Project Name: SHOP Addition  
Persigo Treatment

### - SHOP ADDITION - PERSIGO WASTEWATER TREATMENT PLANT

# REVIEW COMMENTS

TITLE HEADING: Site Plan Review - Addition to  
Persigo

GRAND JUNCTION/ MESA COUNTY, COLORADO  
**PERSIGO WASH WASTEWATER TREATMENT PLANT**  
SECTION II SITE WORK  
**SEEDING AND SODDING PLAN**

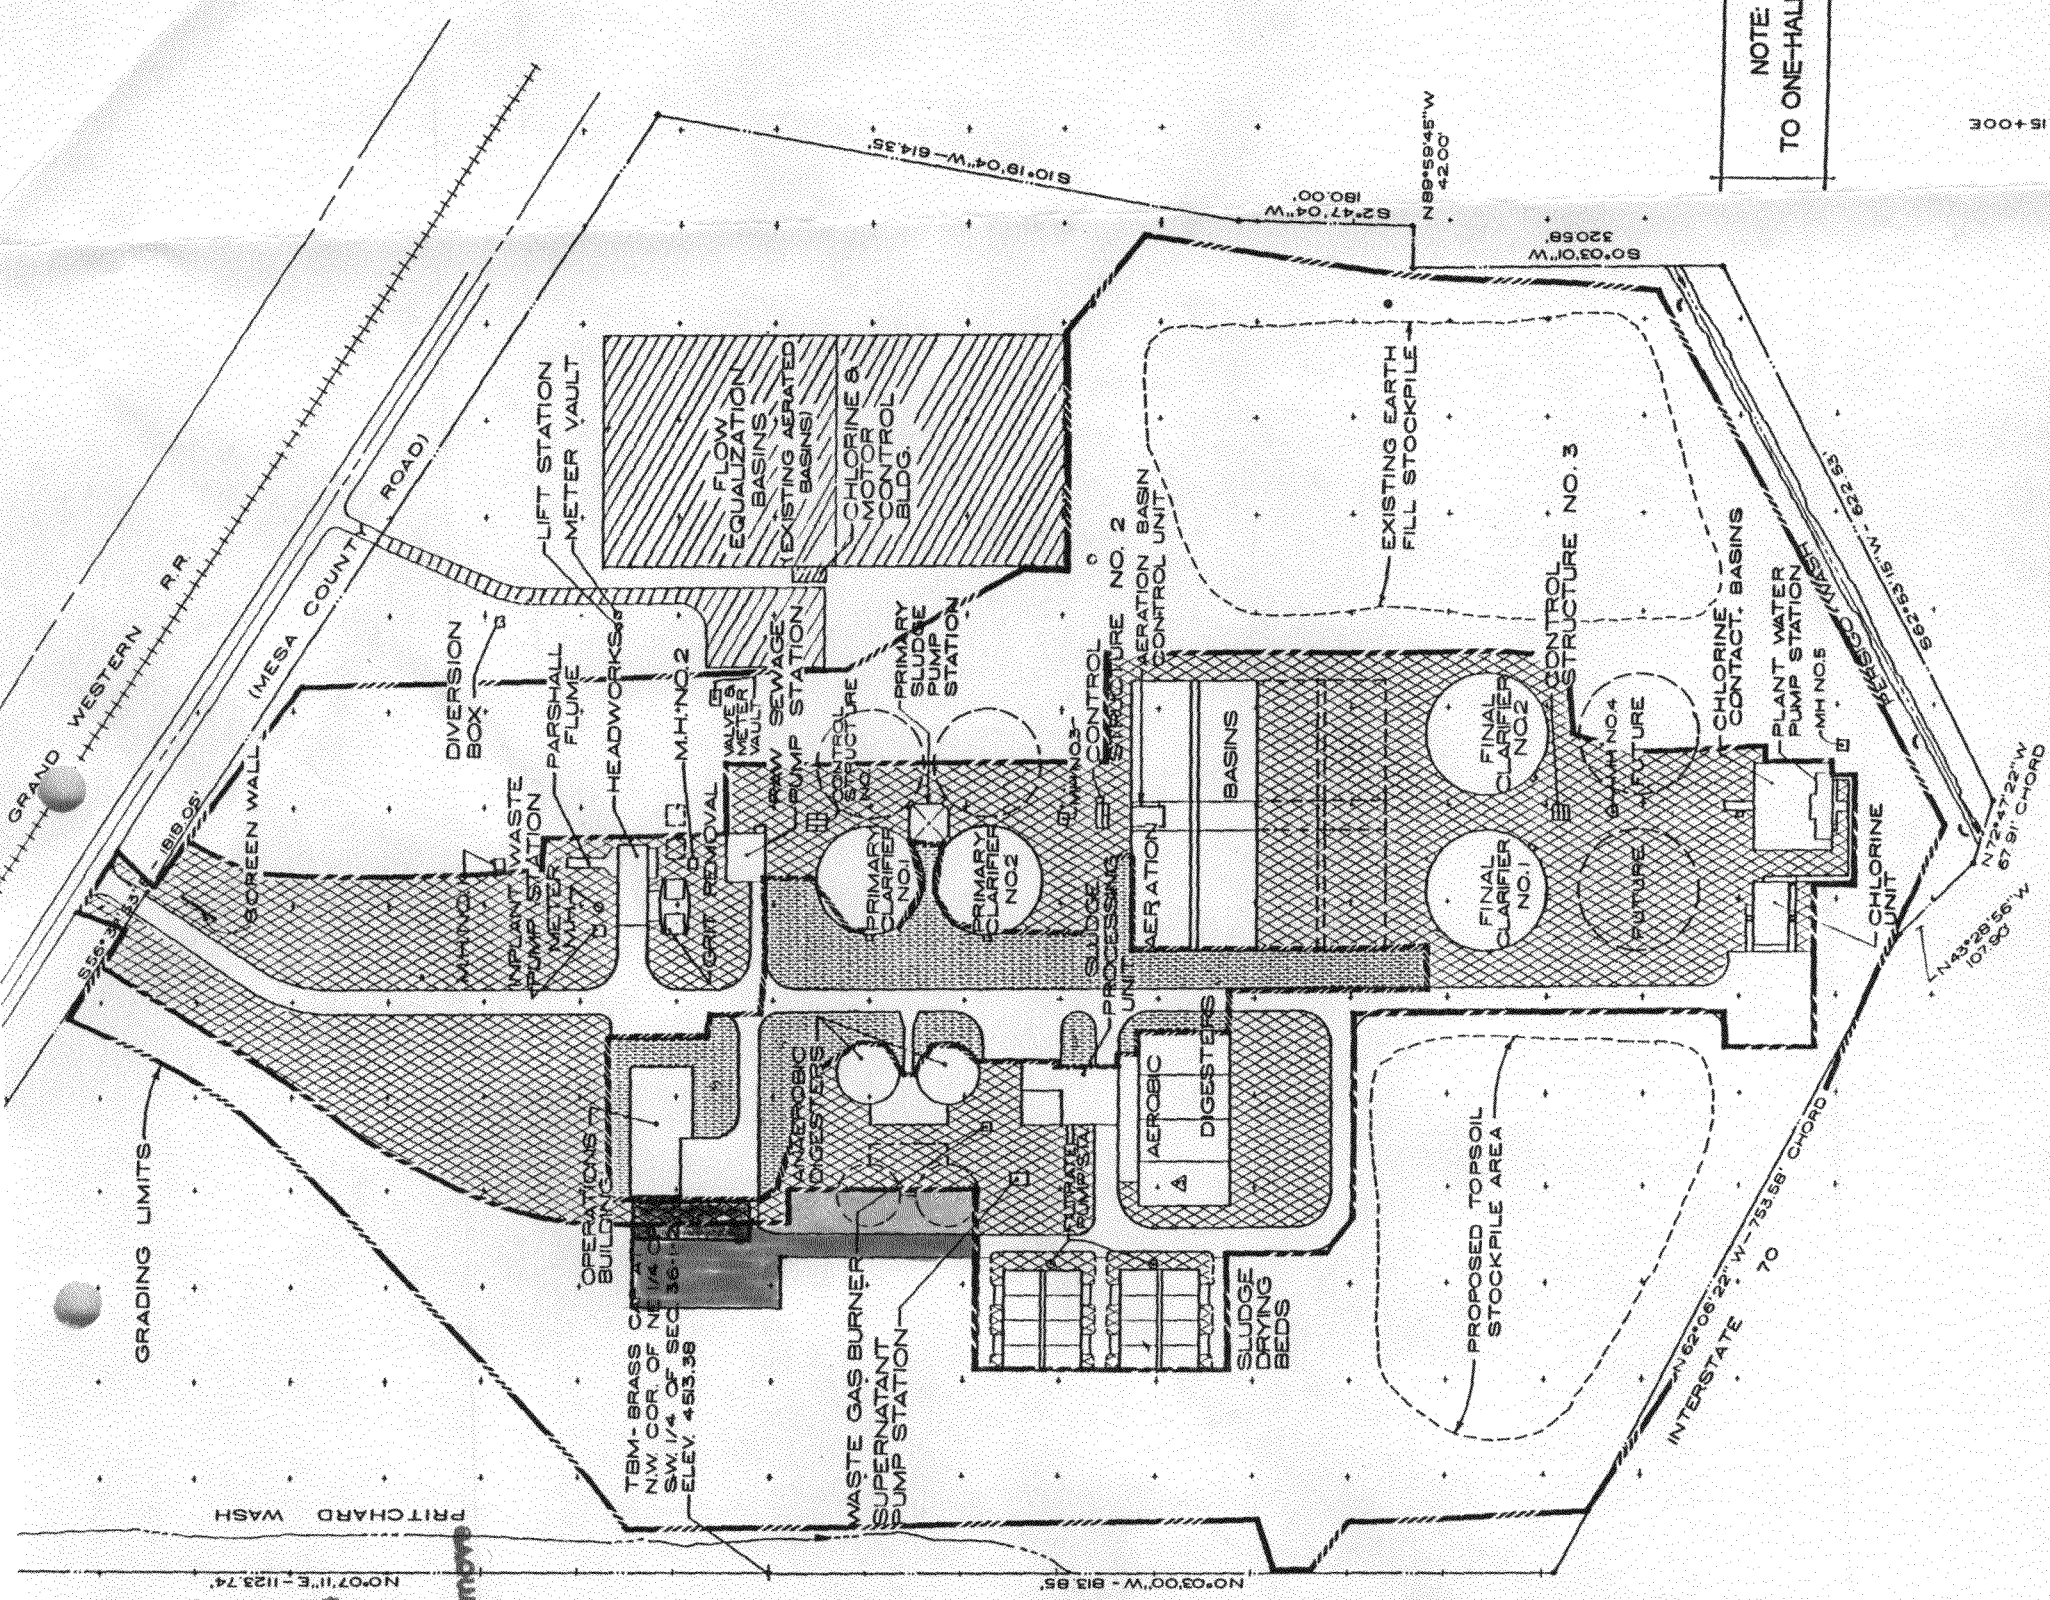
Drainage on-site facilities are already in place, so drainage issues are considered to be addressed.

1. Graveled parking lot meets current code; we would like to see the eventual paving of it though.
2. Total area of landscaping meets code requirements.
3. Planning clearance may be issued.
